Re: Zircaloy Clad  
Conversion  
ISAP Topic 2.17

Haddam Neck Plant  
Additional Information  
Small-Break Loss of Coolant Accident Analysis--  
Zircaloy Clad Fuel

Attachment  
Haddam Neck Plant  
Additional Information

**FIGURE 12-1**  
**HADDAM NECK PLANT ZIRCALOY SBLOCA**  
**0.01 FT2 DISCHARGE LEG BREAK**  
HEAT TRANS. COEFF. - HOT SPOT

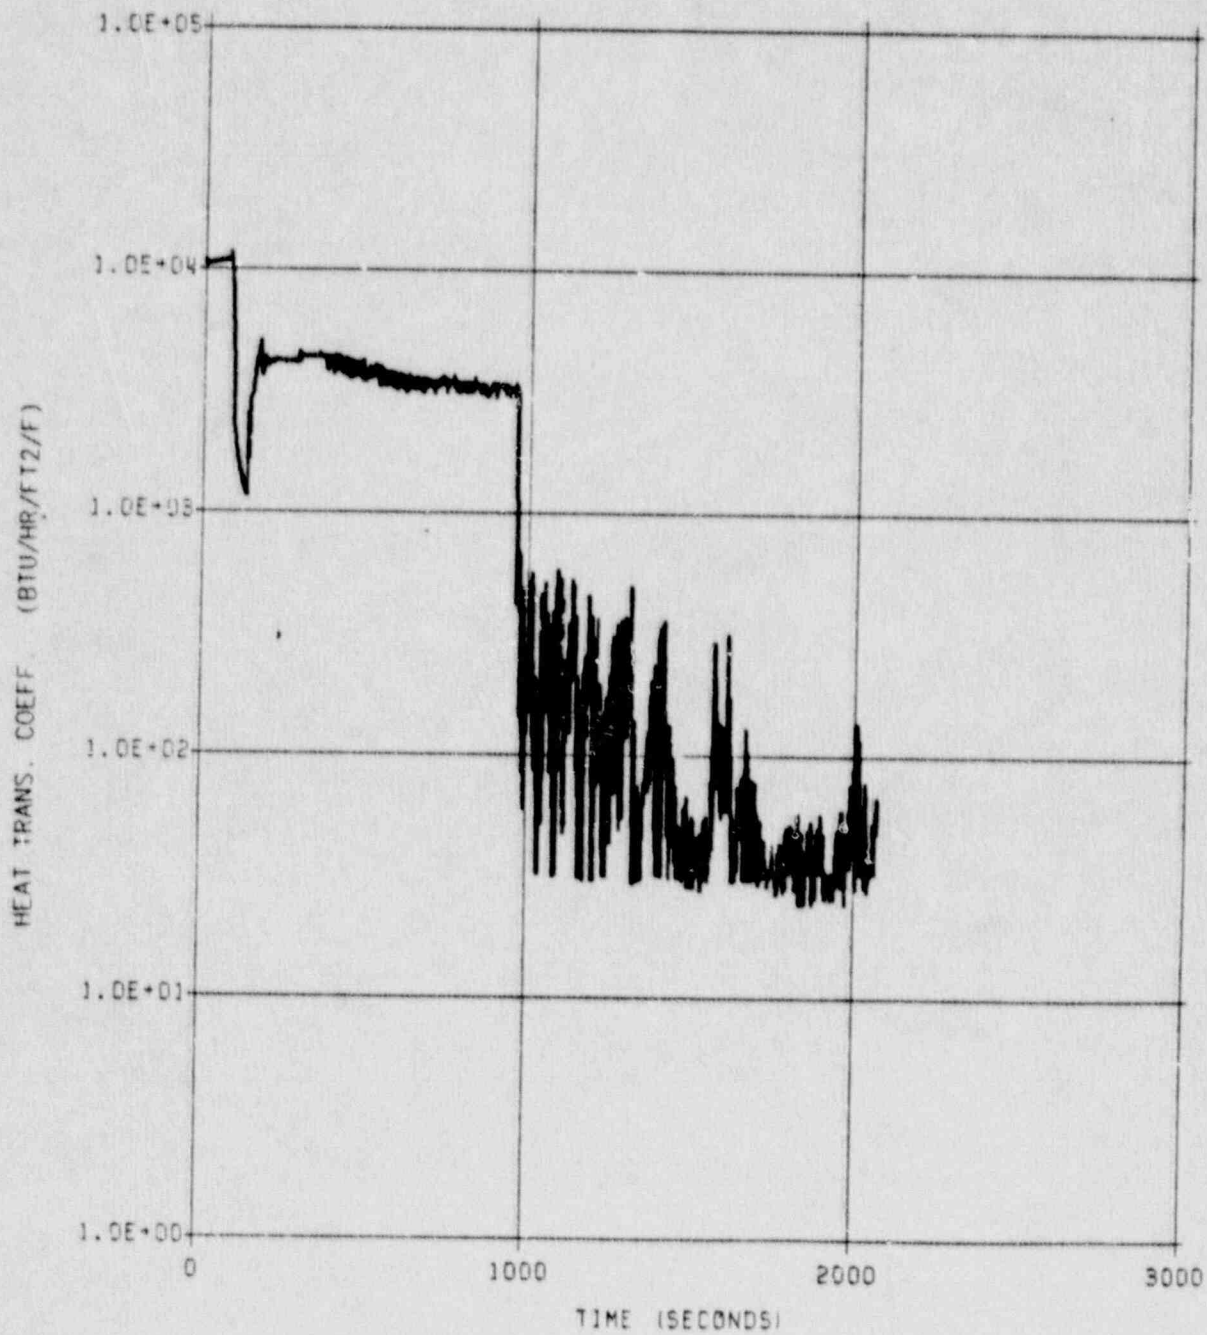
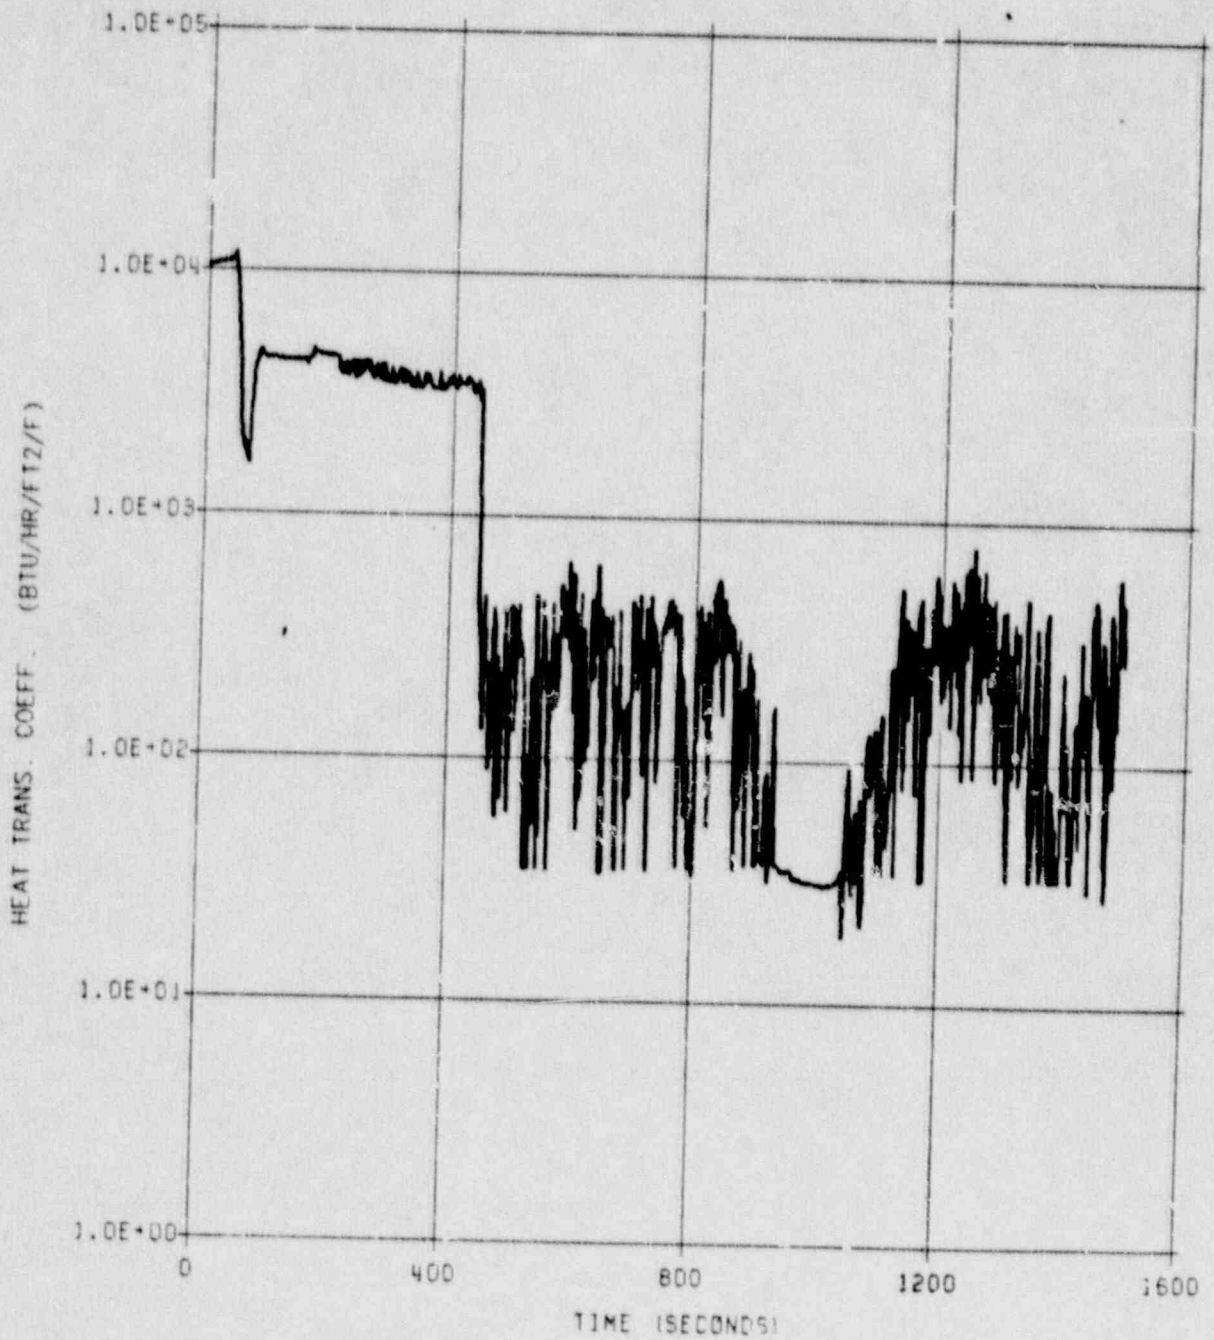
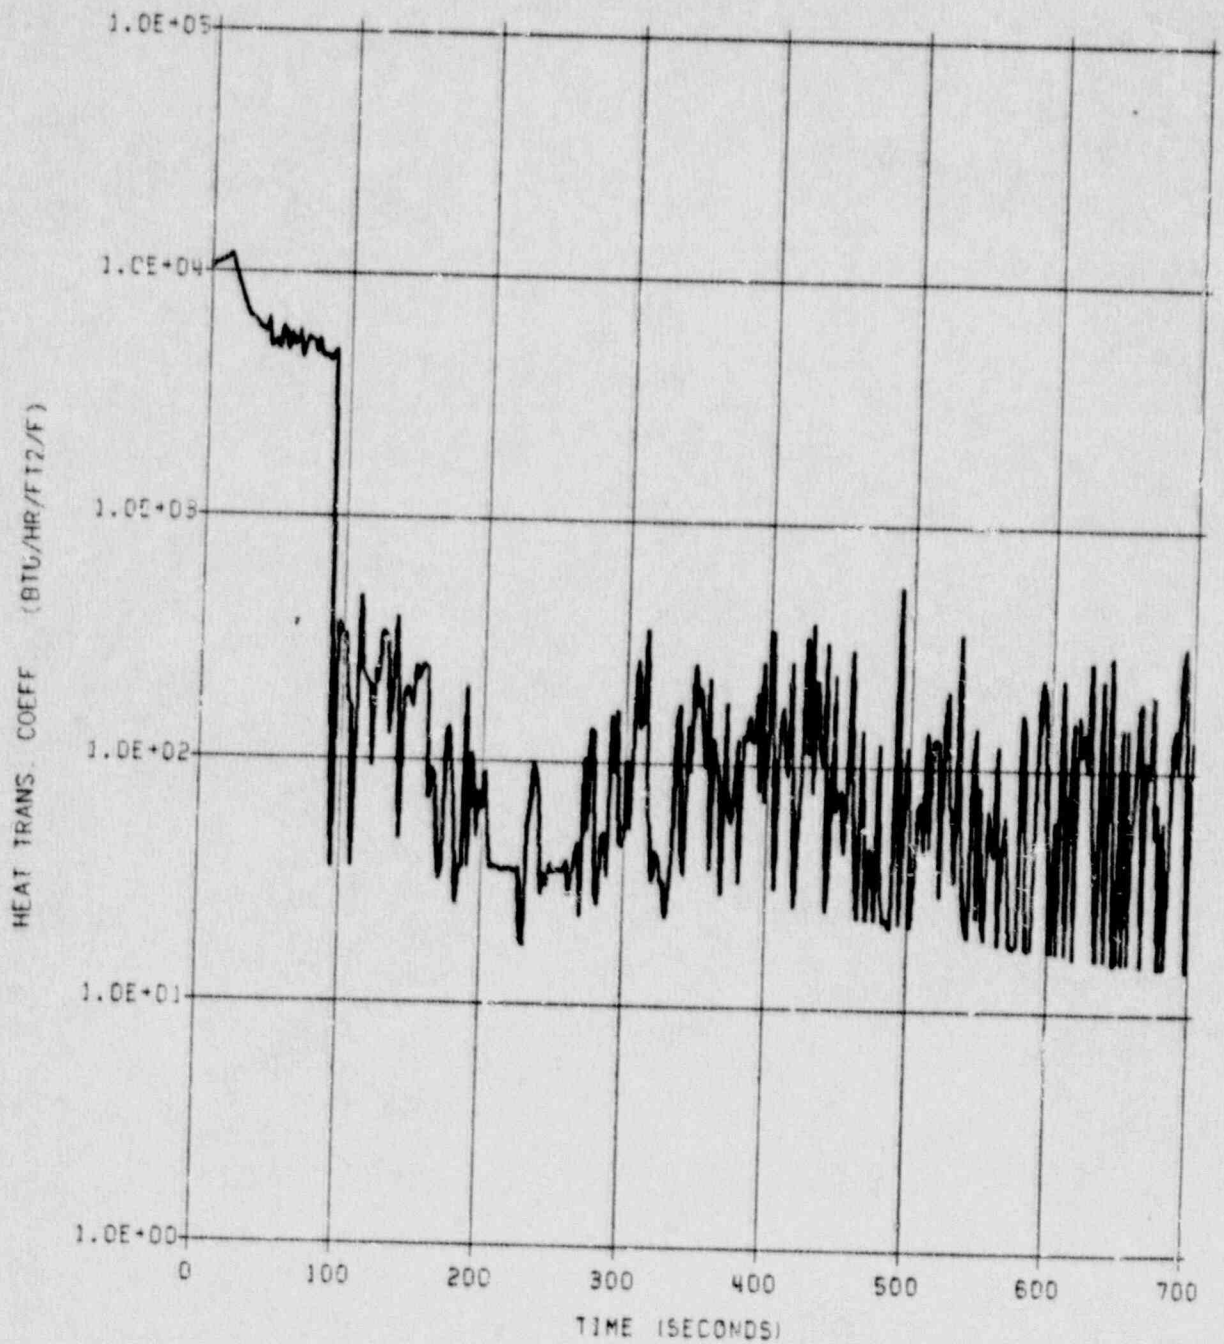
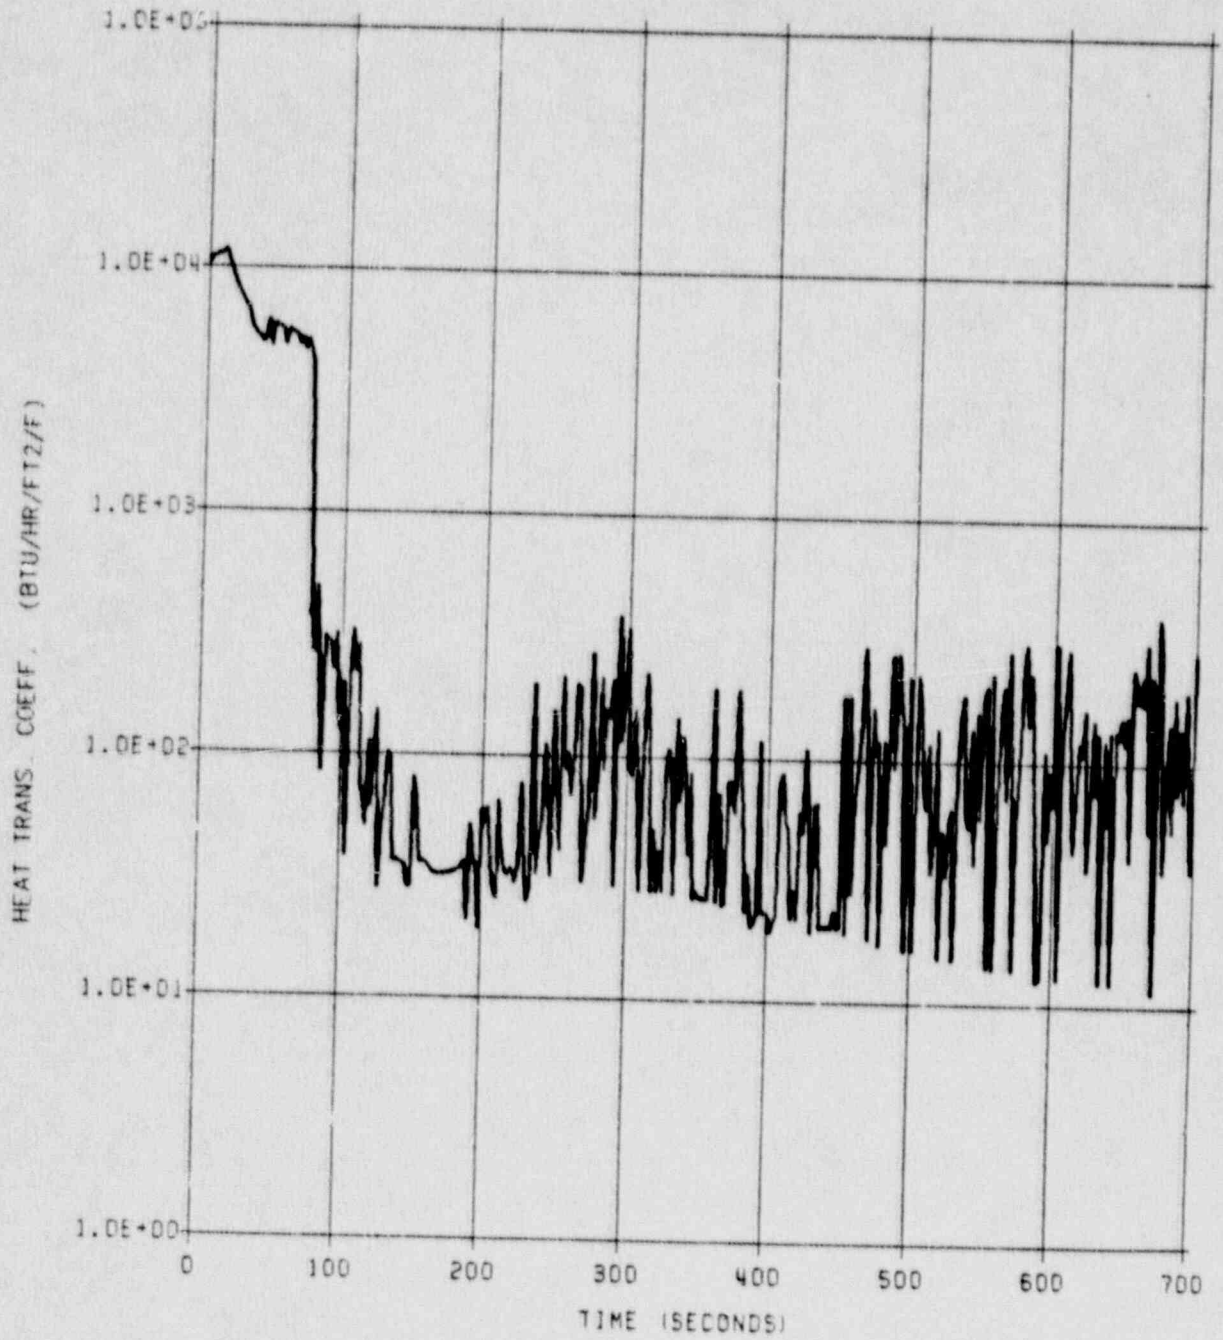
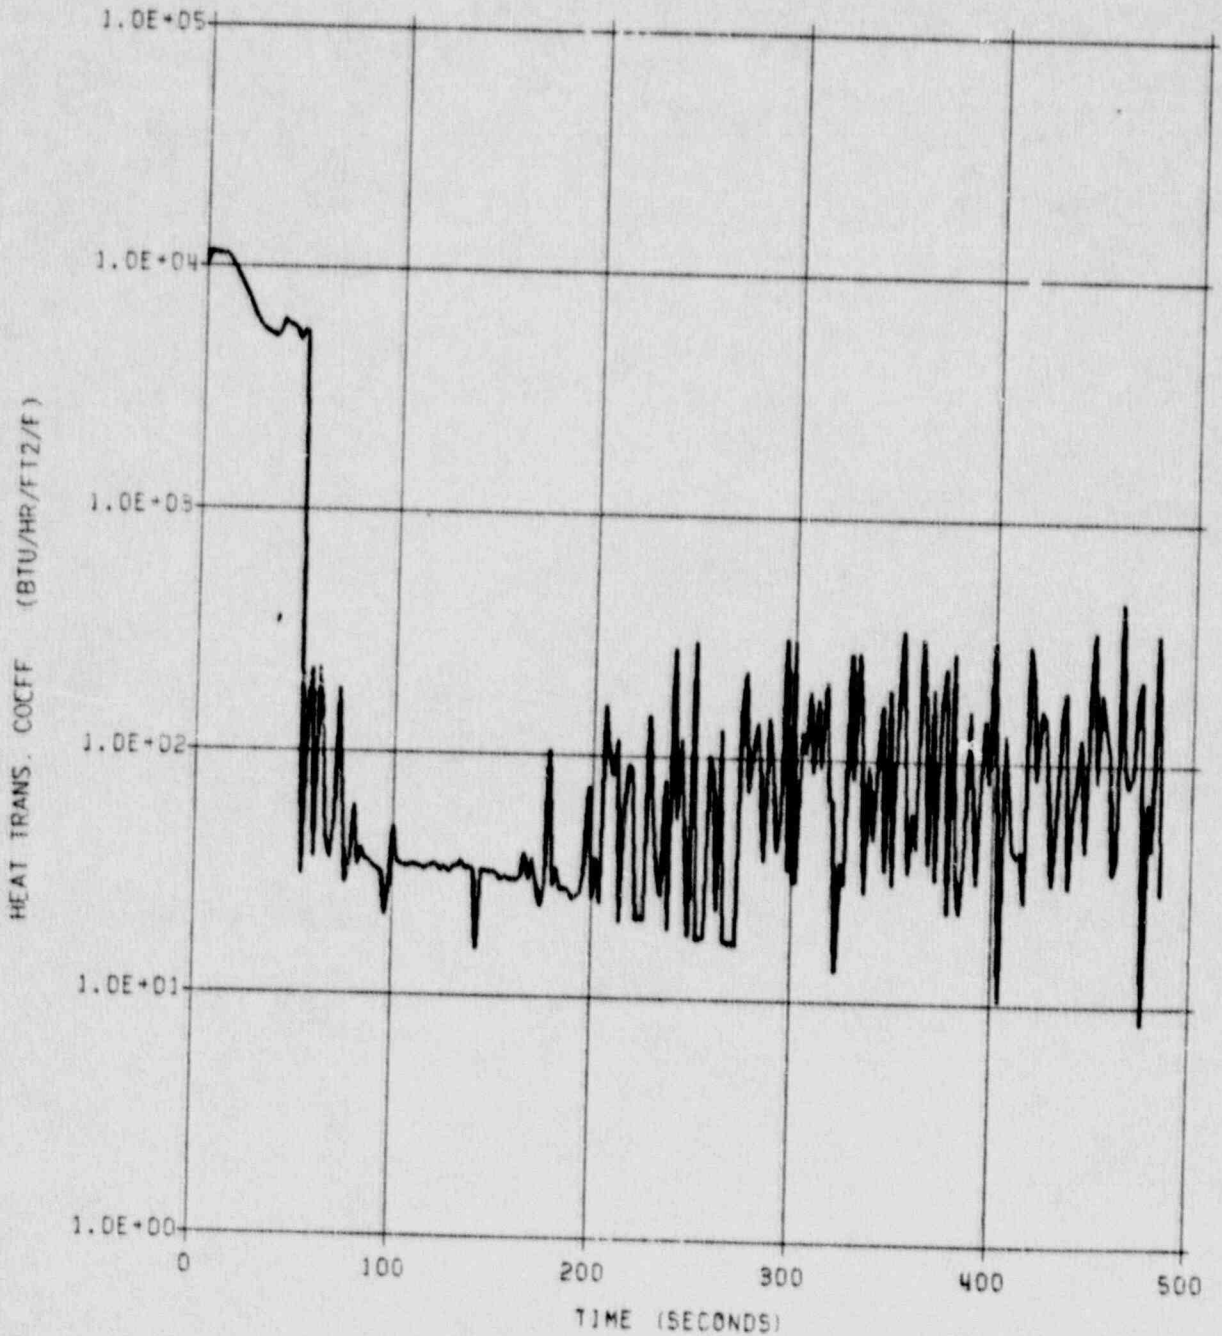
The heat transfer coefficient in Figures 24 is difficult to interpret at values below 500 Btu/hr/sq. ft./F. Please provide an additional plot or tabulated data (0-500) so that the variation of the heat transfer coefficient for the latter portion of the transient, particularly when steam cooling governs the heatup of the hot rod, may be reviewed.

Figures 12-1 through 12-6 provide the surface heat transfer coefficient at the hot spot plotted on a log scale for each of the breaks provided in NUSCO 163.
